**Anchor QEA Memorandum
“Response to U.S. Army Corp of Engineers’ Request
for Additional Information”**

To: Erin Legge, U.S. Army Corps of Engineers **Date:** March 28, 2013
From: Heather Griffin, City of Everett
Heather Page, Anchor QEA, LLC
Re: Kimberly Clark DWO Project (NWS-2000-34)
Response to U.S. Army Corps of Engineers' Request for Additional Information

MTCA SAMPLING FIGURES

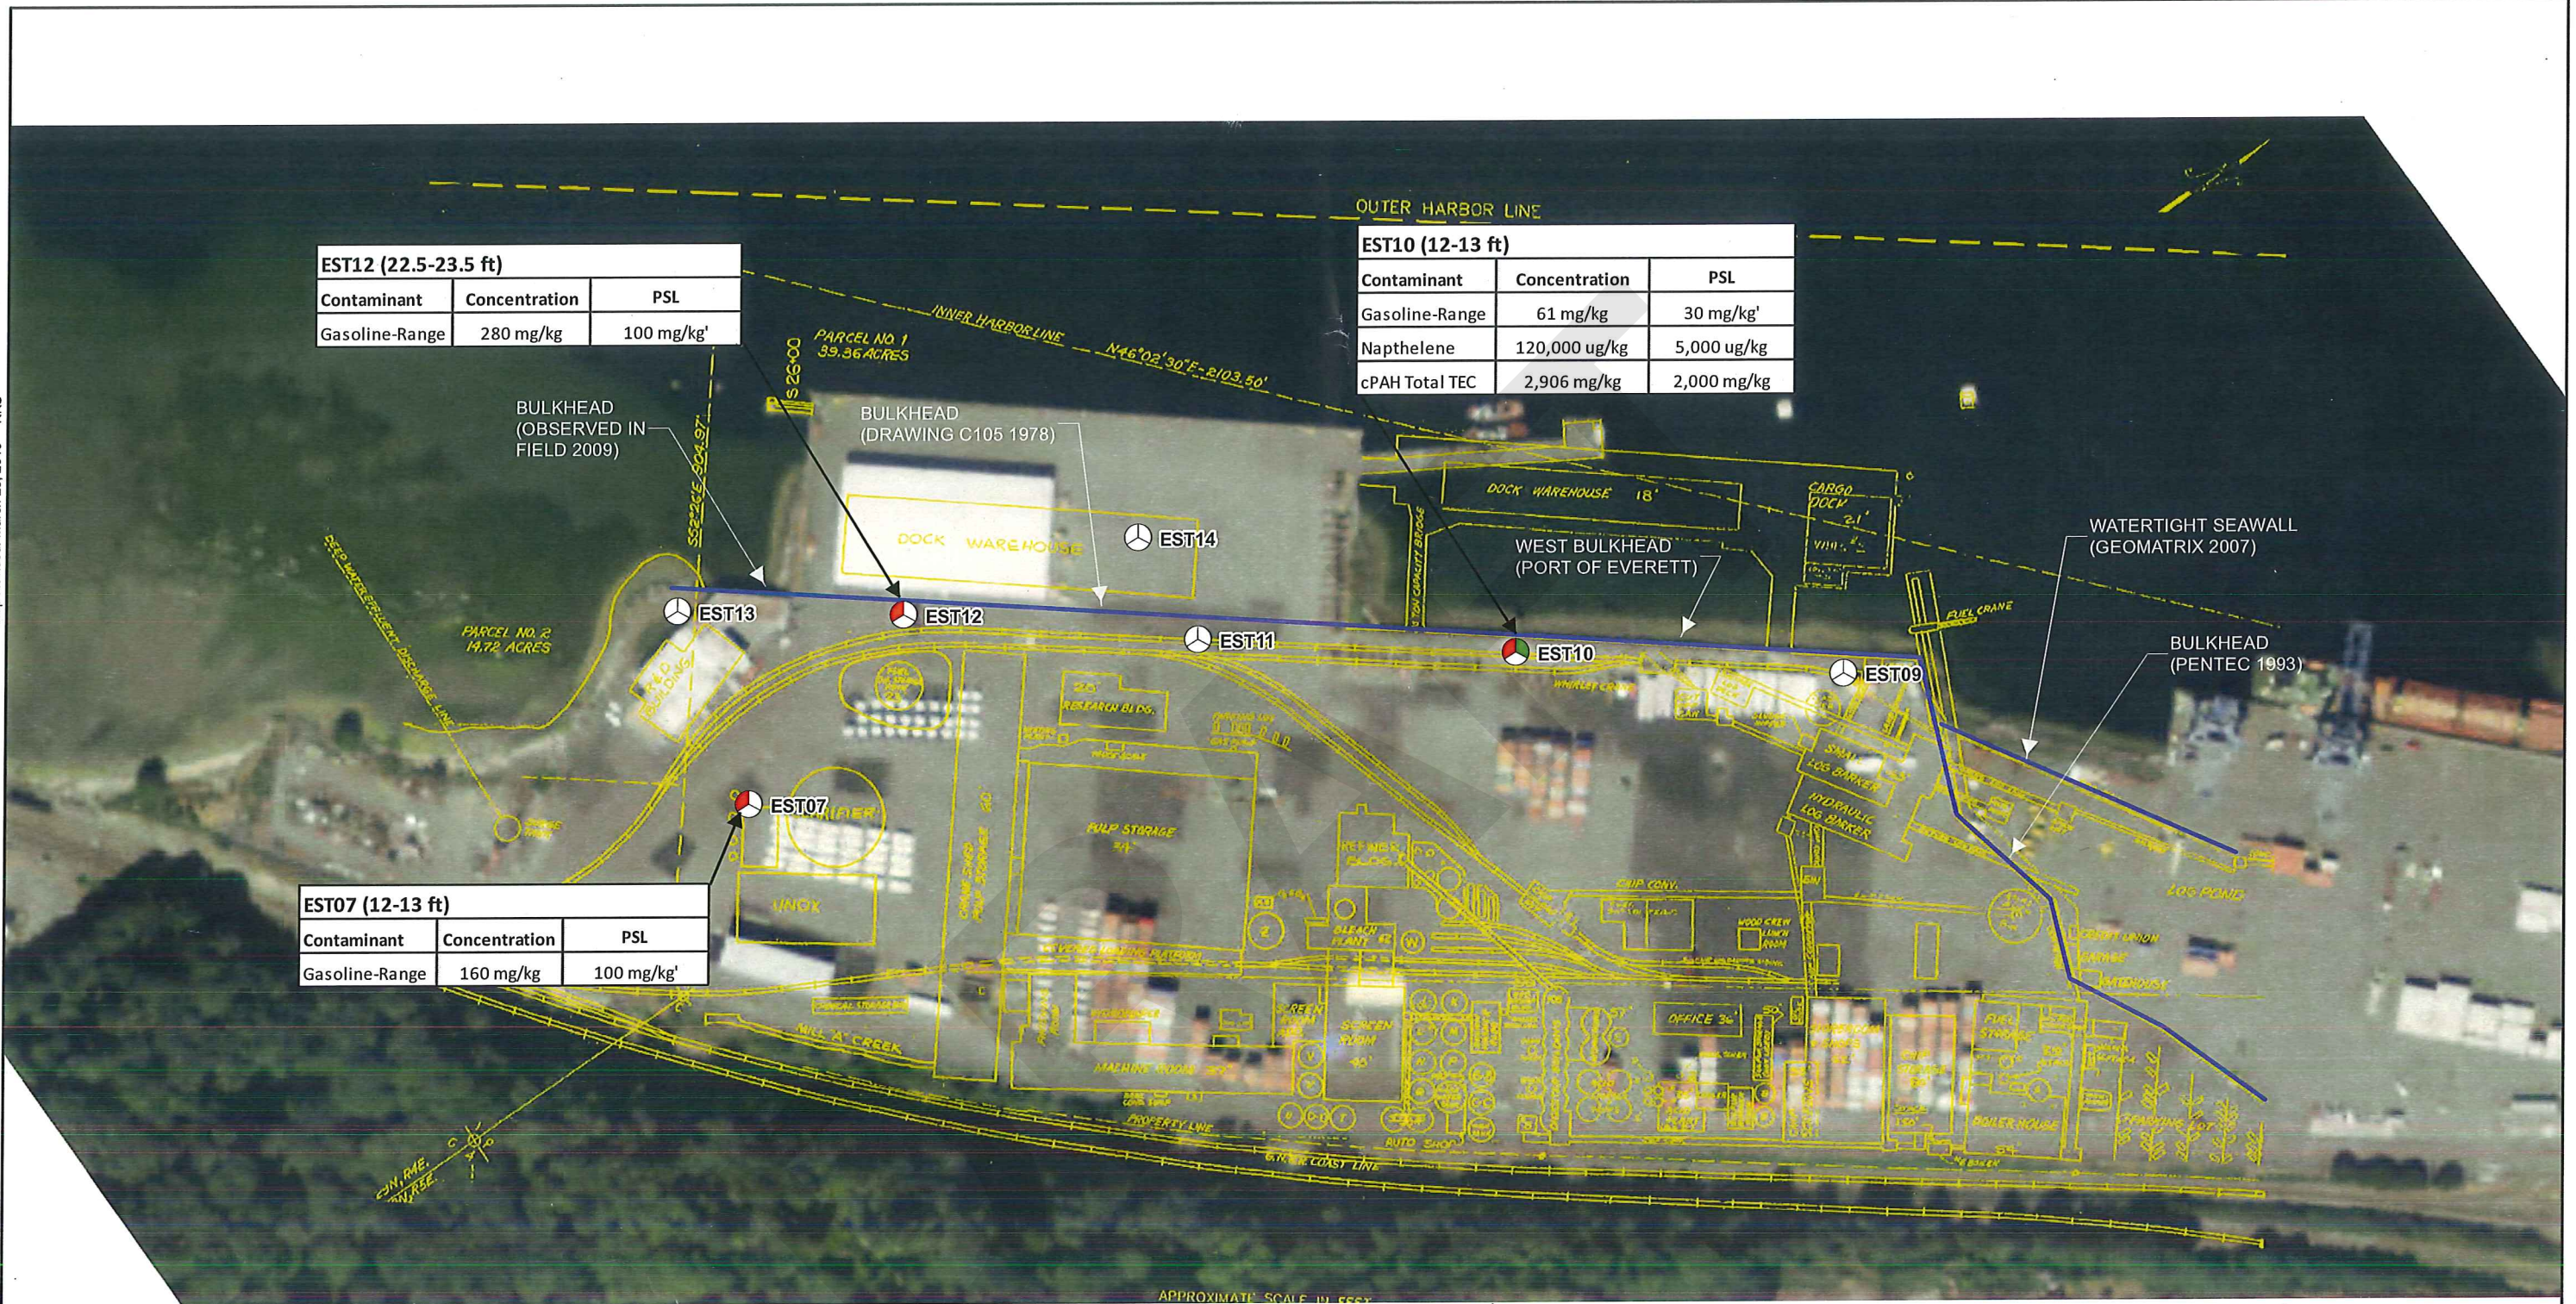
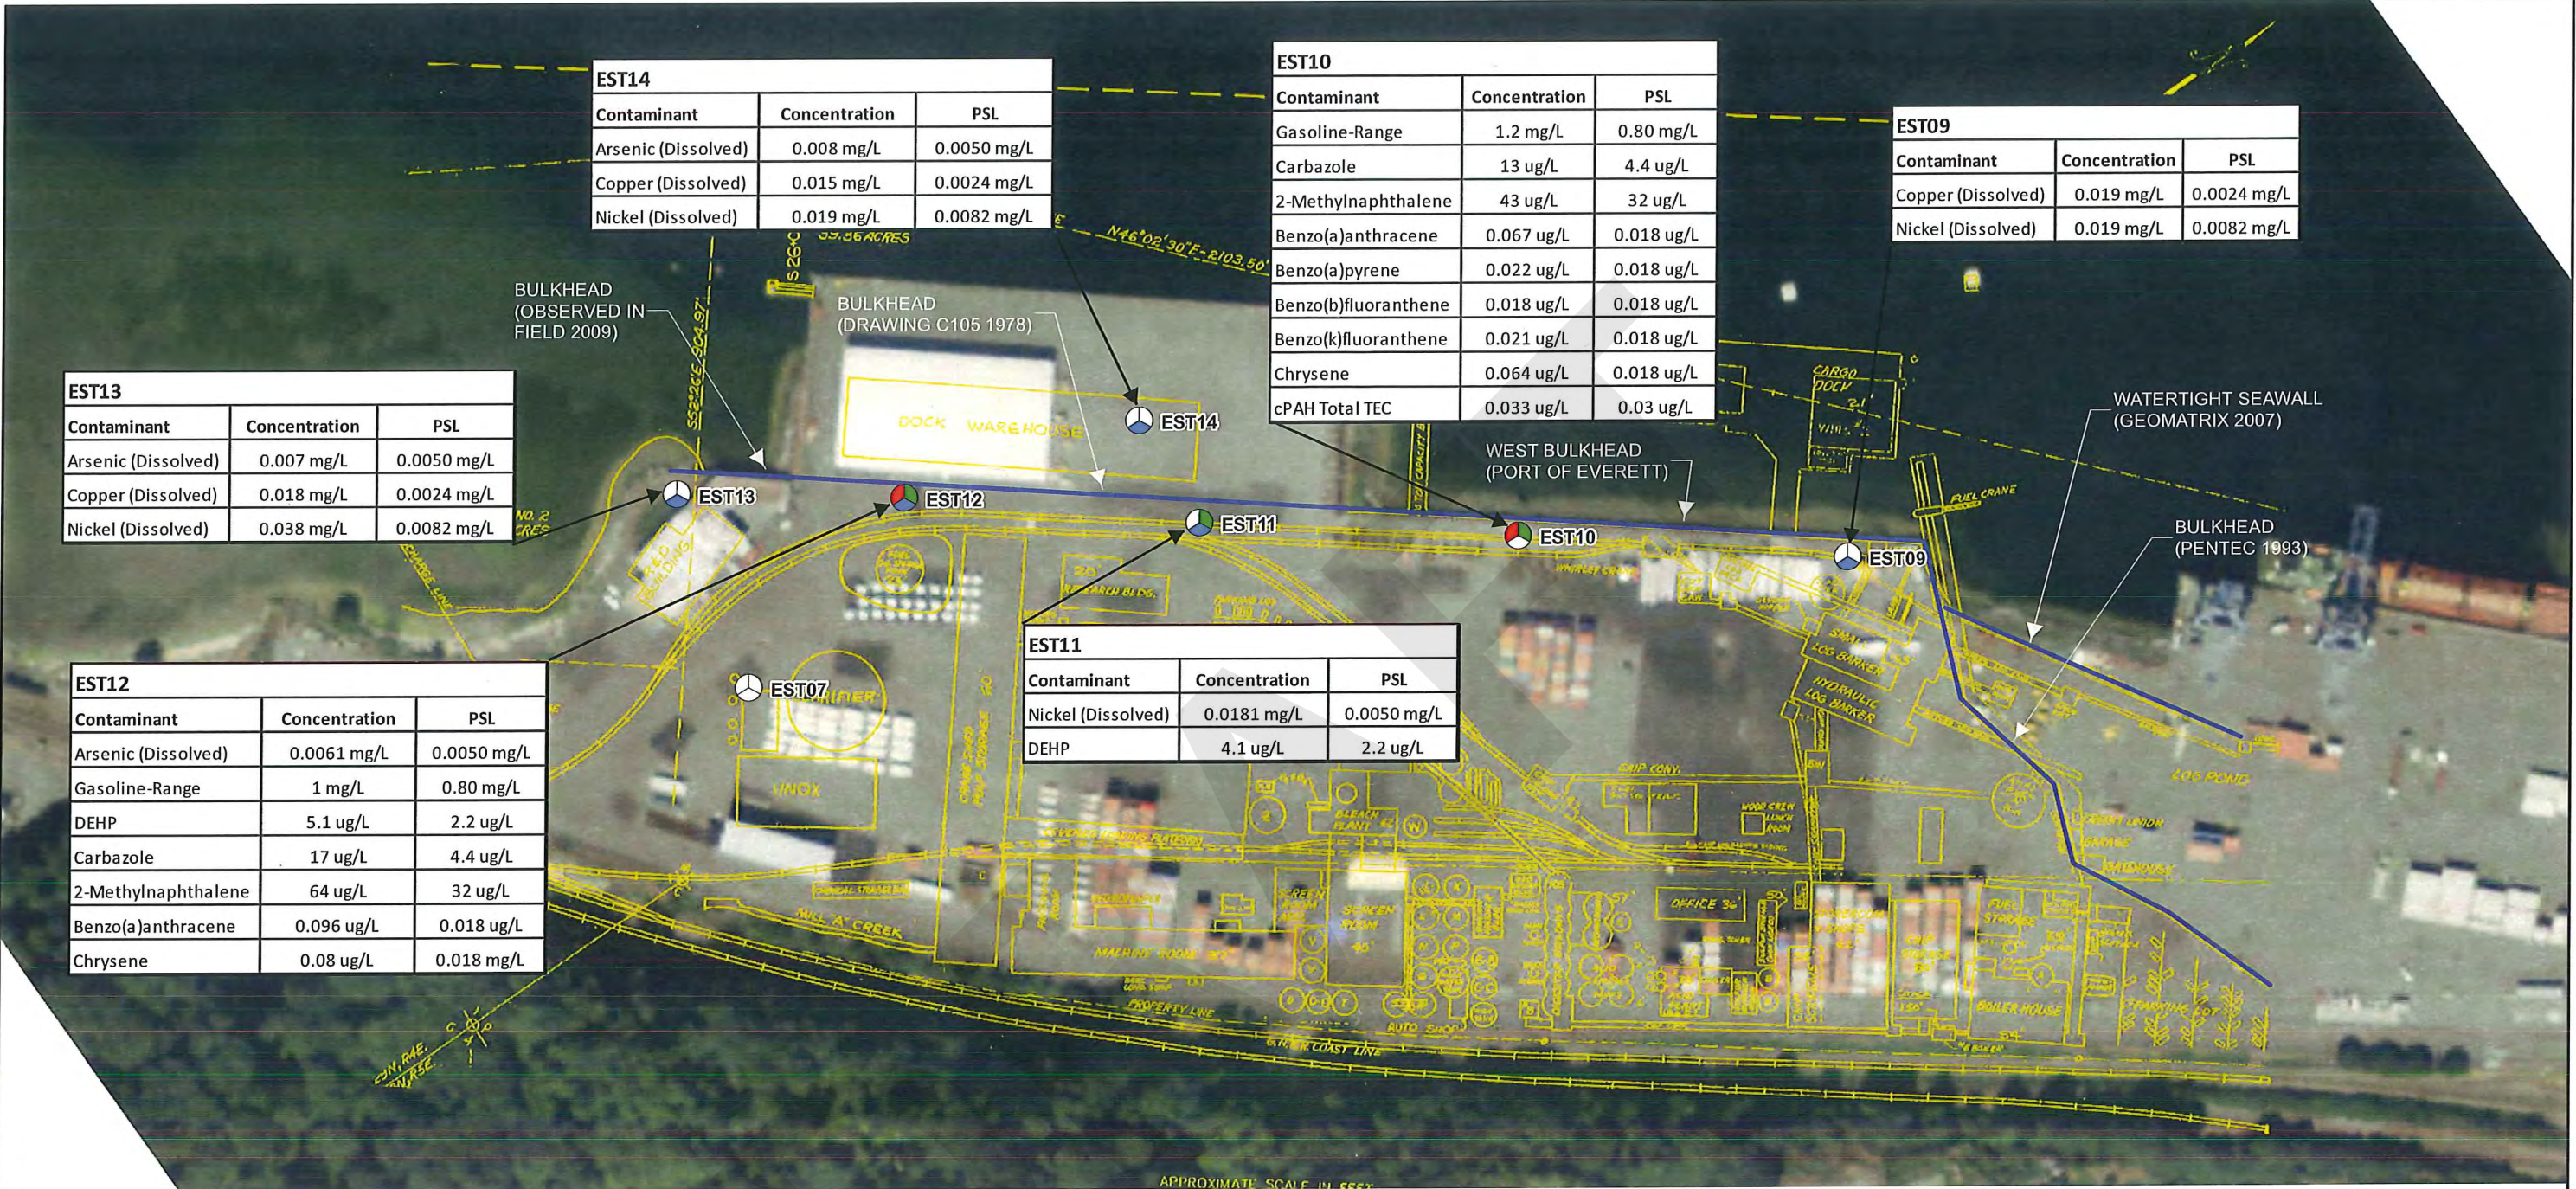
WHERE IS THE SITE IN RELATION TO A MODEL TOXICS CONTROL ACT (MTCA) CLEAN UP AREA?

As an update to the City's response in JARPA Question 9.i., the project site has no known contaminated sediment. According to the Washington State Department of Ecology (Ecology)/Port, the project is within the Weyerhaeuser Mill A Former Model Toxics Control Act (MTCA) Site, which has known sediment contamination. The nature and extent of contamination has not been defined for this Site and will be determined as part of the Remedial Investigation/Feasibility Study (RI/FS). Please note that there have been no documented exceedances of the cleanup standards within the KCDWO Project area (see figures in Attachment 3).
